Attn: Thomas Piovesan, Planning Officer  
Re: SSD-70066710, Hudson Vine Mixed Use Redevelopment

Thank you for the opportunity to make a submission on the Hudson Vine Mixed Use Redevelopment State Significant Development 70066710.

Figure 1 Sunlight begins to reach Vine St front windows around 8 am

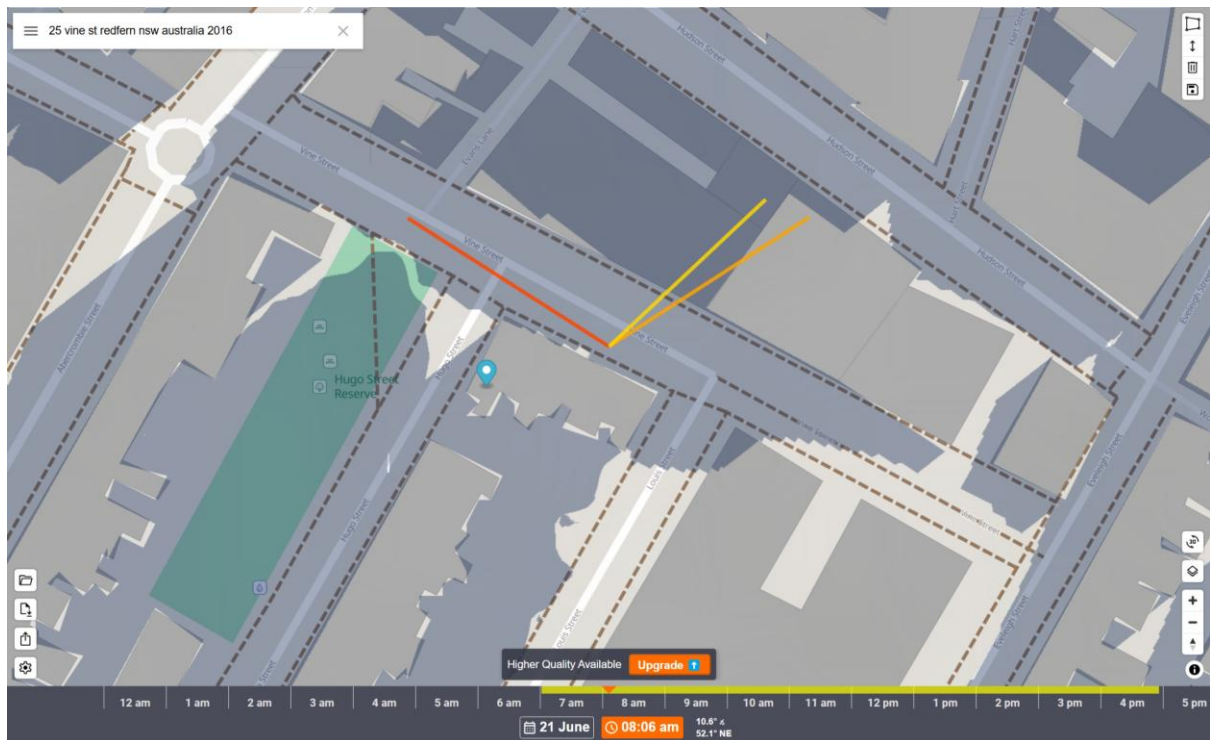
A calculation of the existing solar access can be determined using the ShadeMap website. This shows existing solar access on 21 June is available between approximately 8am and 5pm, providing ~9 hours of sun:<sup>9</sup>

Figure 3 Sunlight leaves Vine St terrace front windows around 5 pm

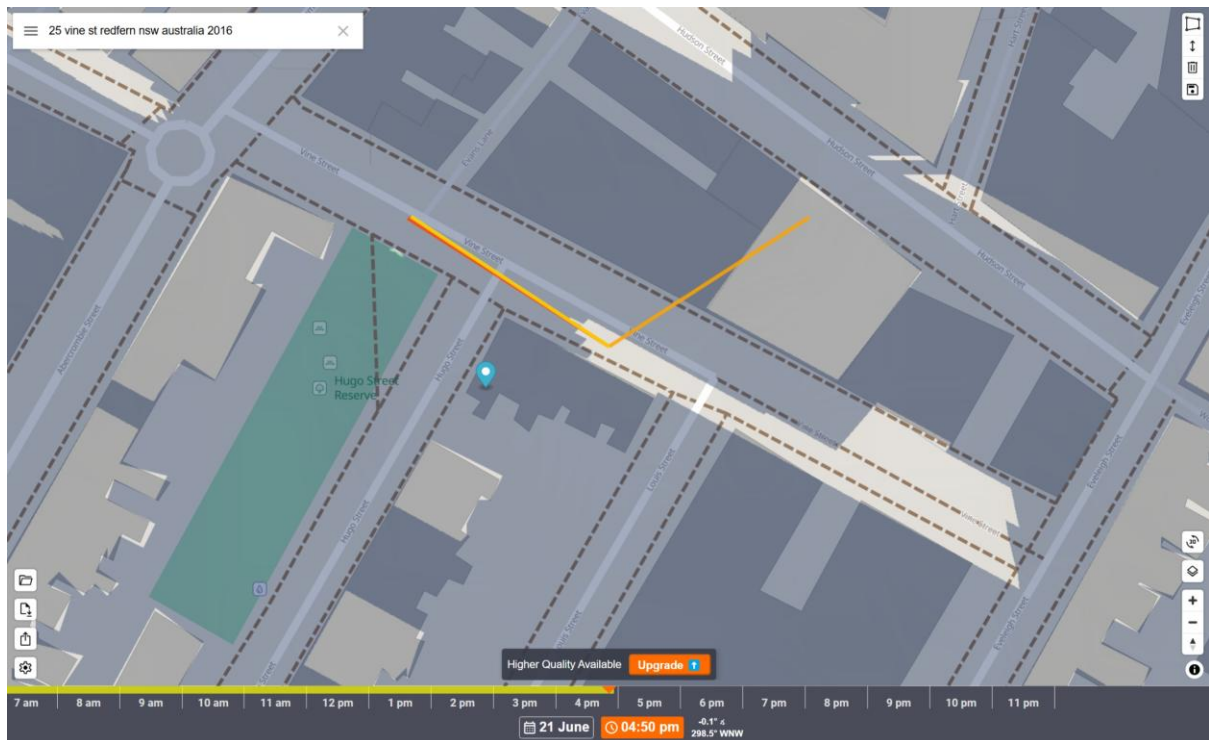
The proposed building will cause a loss of 5 hours of sunlight when compared to the existing situation, a 55% reduction. Between 9 am and 3 pm, 4 hours of sunlight are lost and only 2 hours are retained, a 66% reduction. This results in a major reduction in the amenity of the Vine St terraces to receive warmth and light from the sun.

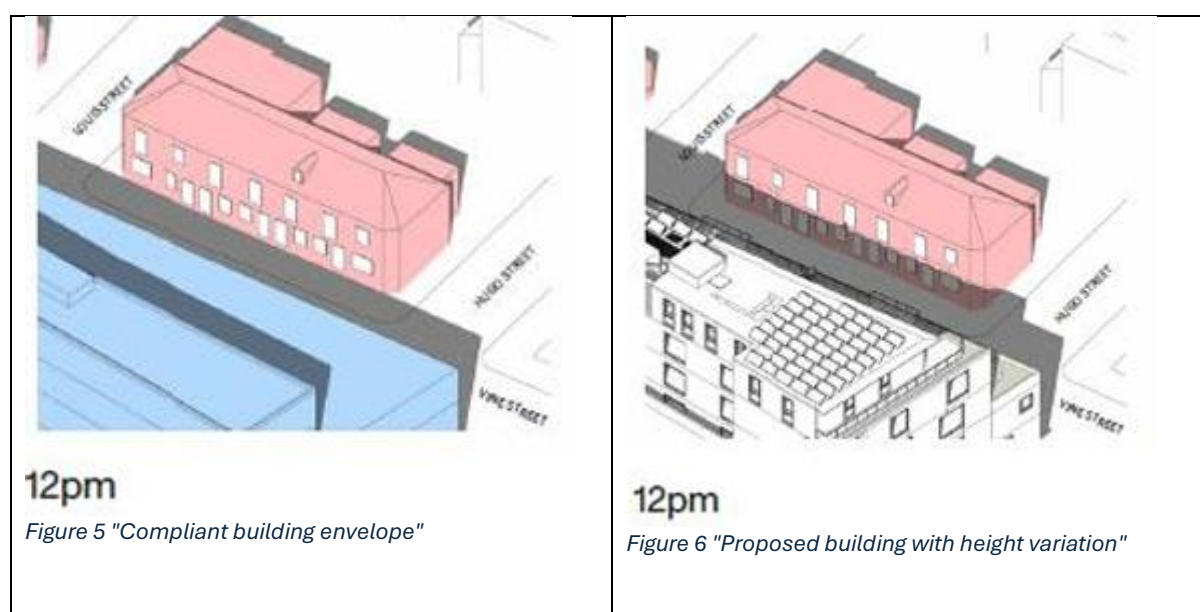
The EIS does not demonstrate how overshadowing to the Vine St terraces is “minimised” as required by the ADG.

The assertion in the EIS that “there is no additional overshadowing” is unsupported. The diagrams show that increased solar access would be achieved with a “compliant building”. At 12pm of the “compliant building envelope”, there are no shadows cast on the living room windows of the Vine St terraces. In contrast, the proposed building will cast shadows on the living room windows until 1pm.

The proposal should be rejected or amended to minimise overshadowing of neighbouring properties because it breaches the ADG design guidance:

- A figurative “compliant building envelope” would minimise overshadowing when compared to the proposed building envelope
- The proposal significantly reduces the solar access of terraces on Vine St but does not increase building separation accordingly
- The proposal does not demonstrate increased upper-level setbacks to minimise overshadowing to the south; instead, the proposal is non-compliant and encroaches the setbacks required by the height controls

Figure 7 Design Report "context analysis" (with orange lines added)

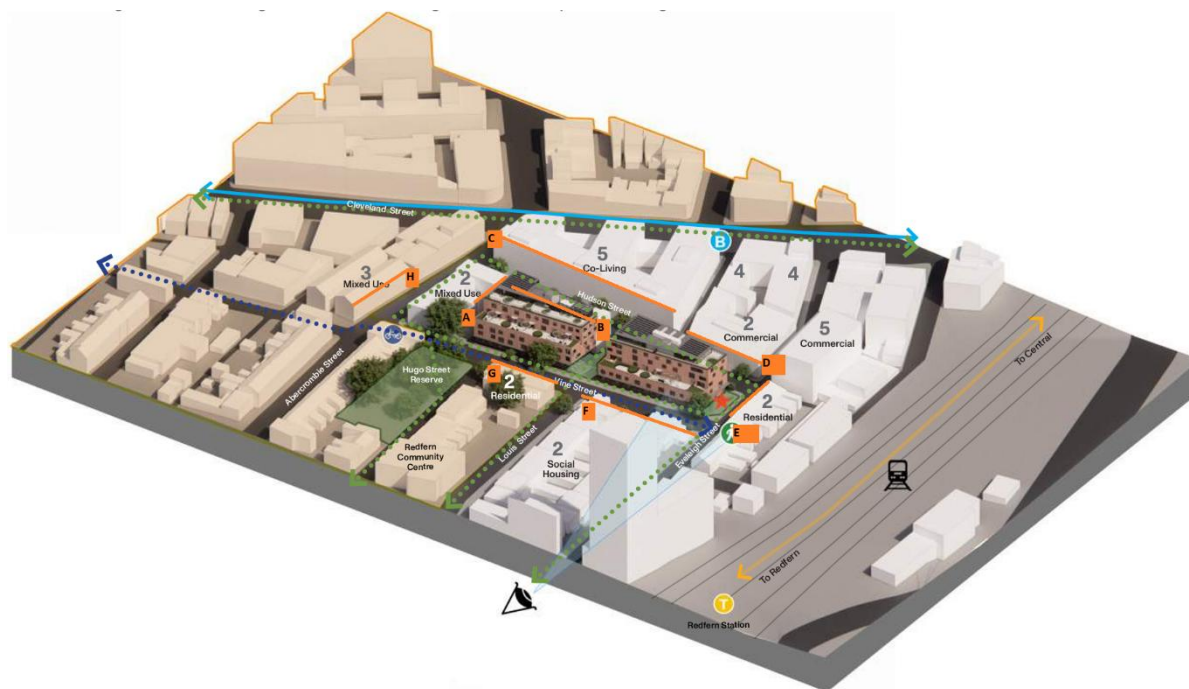
The graphic has been amended with orange lines marked with letters A-H to highlight the sudden changes in building heights. The height of the tallest proposed building (RL 42.650) is significantly higher than the surrounding buildings:

The EIS is factually incorrect to state that the proposed building matches the prevailing scale of the surrounding buildings.

- There is a significant 5-storey difference between 146-158 Abercrombie St (“A”) and the proposed building. The applicant has not provided any evidence to show how this matches the prevailing scale.
- The proposed building almost doubles the number of storeys of the adjacent 5 Hudson St (“B”) with a 3.6-storey difference. Notably, the applicant’s diagram (Figure 7 Design Report “context analysis” (with orange lines added)) omits displaying the number of storeys of this building, illustrating how the proposed scale overwhelms its surroundings.
- Most buildings in this area, as shown on the diagram, are 3 storeys or lower. The average building height of surrounding buildings noted in the table is 10.6 metres, contrasting sharply with the proposed building’s 6 storeys or 23 metres. It is wrong to contend that such a height represents the prevailing scale.

The proposal should be refused or amended to respond and transition to matches the prevailing scale.

Figure 10 Short Section A (with additional notes in orange)

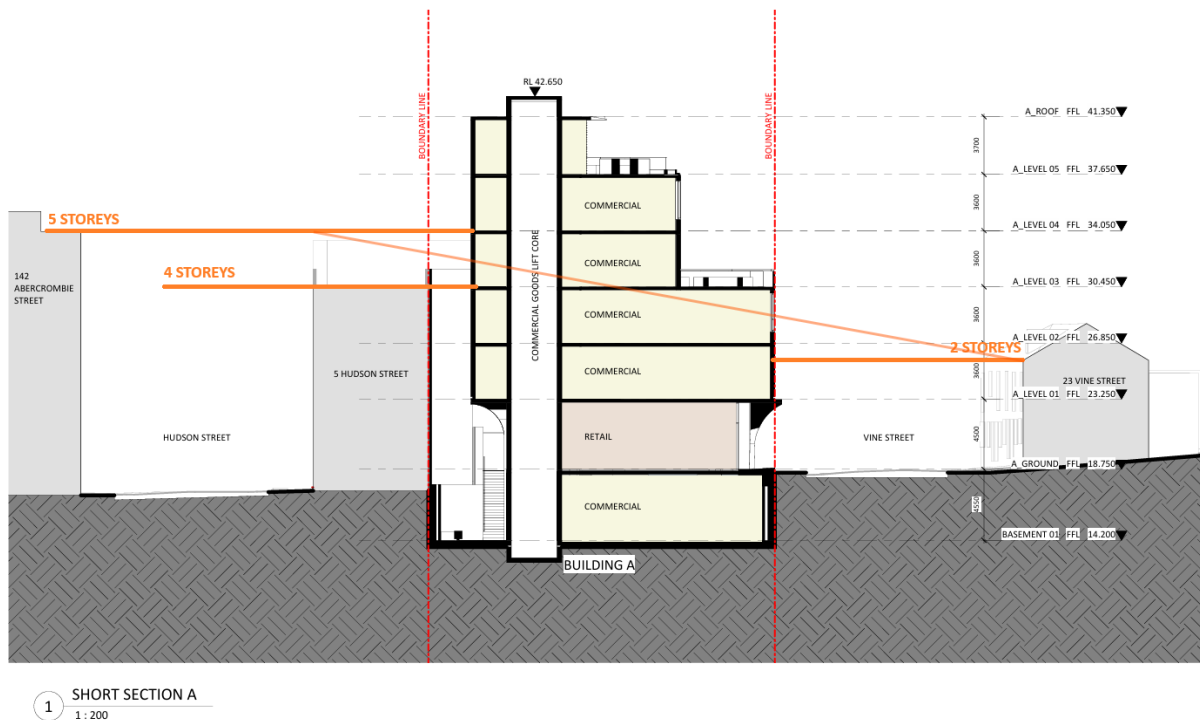
Additional notes have been added in orange, highlighting:

- 2 storeys of the proposed building already exceed the height of the 2 storey terraces at 23 Vine Street
- 3 storeys of the proposed building match the height of the 4-storey mixed use building at 5 Hudson Street
- 4 storeys of the proposed building match the height of the 5-storey residential building at 142 Abercrombie Street
- A building with a responsive design should follow the diagonal line from 5 storeys to 2 storeys

Considering the scale of the surrounding buildings, the proposed building matches the size of a 7-storey development. In contrast to *Figure 8 ADG height controls example*, the proposed building exceeds the height of the immediately adjacent building (5 Hudson St), plus both buildings on the other sides of the road (23 Vine Street and 142 Abercrombie Street). Due to most of the surrounding buildings falling within the Darlington Heritage Conservation Area, it is unlikely that their height will change.<sup>45</sup>

The proposal should be refused or amended to ensure that:

- The height, bulk and scale are consistent with impacts reasonably expected for 5 and 3 storey building heights e.g. by lowering the height to 15 metres
- The form and massing respond and provides transition between scales as per the urban design principles of BEP1 e.g. by adding setbacks from 146-158 Abercrombie St and 5 Hudson St
- The aims of the height controls are met under the ADG e.g. by stepping the building down from Hudson St to Vine St, rather than raising the building higher than 142 Abercrombie St.

Figure 11 Visual Impact Assessment camera positions map (with added orange stars)

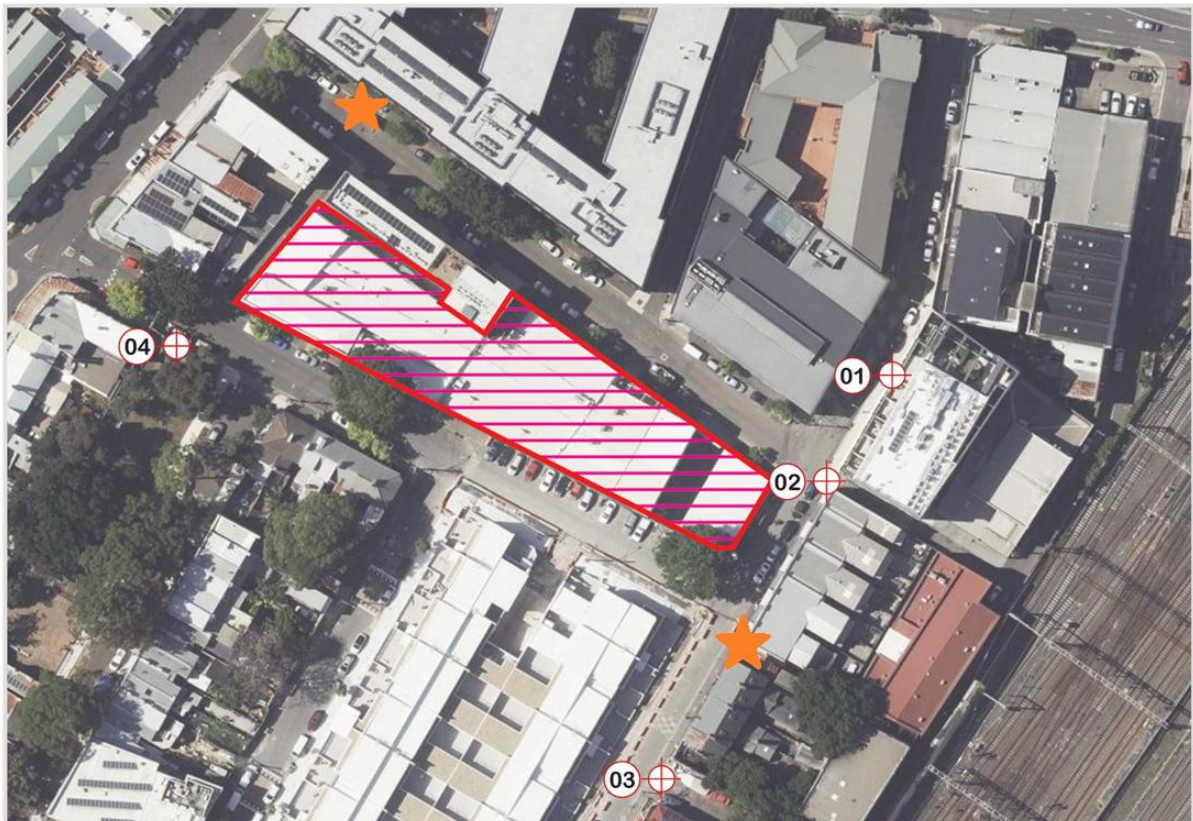
The visual impact assessment omits key viewpoints and do not provide a complete basis for assessing visual impact, as required under the SEARs.

Additional viewpoints, marked with orange stars, should be provided with the proposal:

- A viewpoint at the corner of Vine and Eveleigh Streets, looking down Vine St
- A viewpoint at the corner of Hudson St and Evans Ln, showing the height contrast of the Abercrombie St shop-top housing and 5 Hudson St buildings

The proposal should be refused or amended unless all key viewpoints are shown, as required by SEARs.

Figure 14 West Elevation with proposed building windows

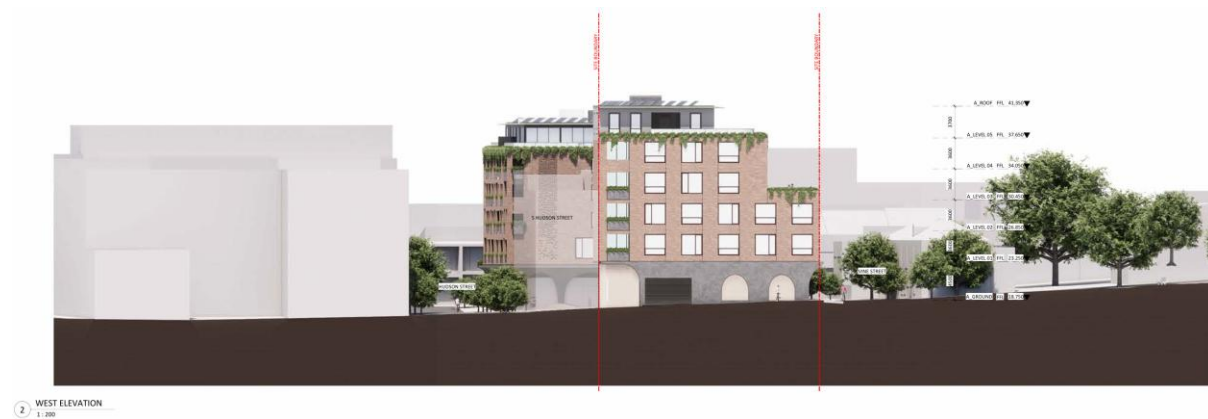
The proposed building windows look directly into the private rear windows of the shop-top housing in 146-158 Abercrombie Street:<sup>48</sup>

This is an unacceptable loss of privacy.

- **Respect privacy of adjoining properties** by removing or screening windows and balconies facing directly into private rear yards and bedrooms.
- **Provide accurate visual impact assessments** from all key public viewpoints, including from street level along Vine Street, to comply with SEARs.

Figure 19 Short Section A (added orange lines showing 5 and 3 storey step down)

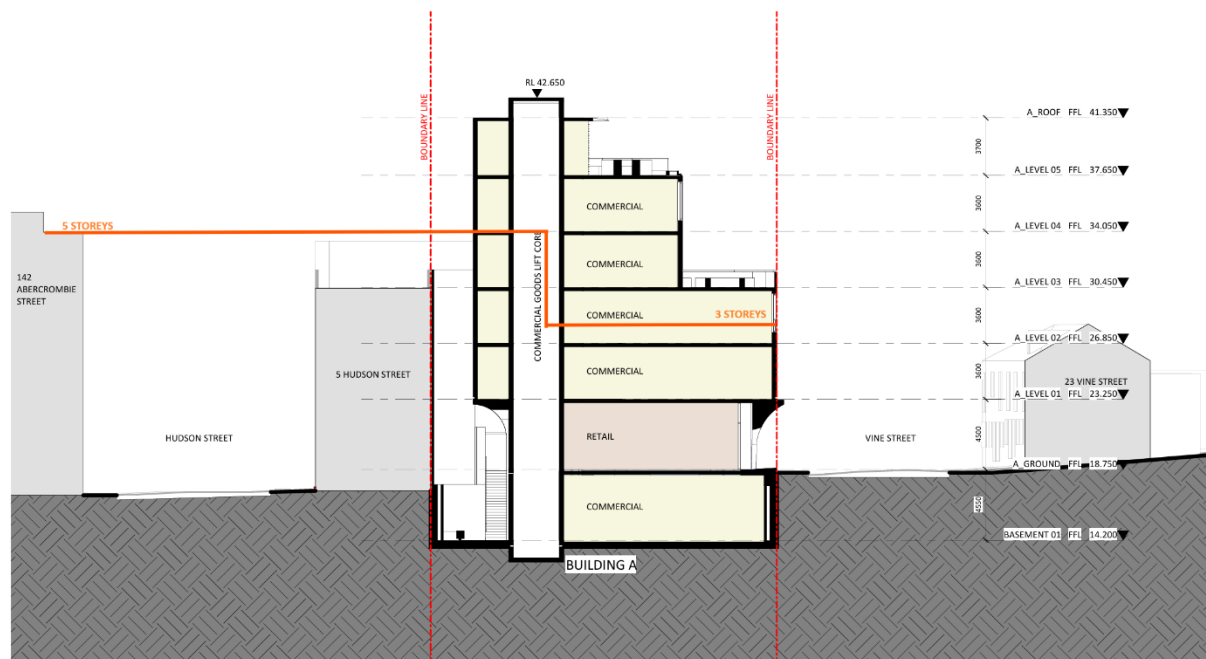
Orange lines have been added to the drawing to demonstrate stepping down from a 5-storeys to 3 storeys. 142 Abercrombie Street is a 5-storey building. The proposed building steps up, not down, to add the non-compliant 6<sup>th</sup> storey. The proposed building upper levels also extend their non-compliant height further south, towards Vine Street.
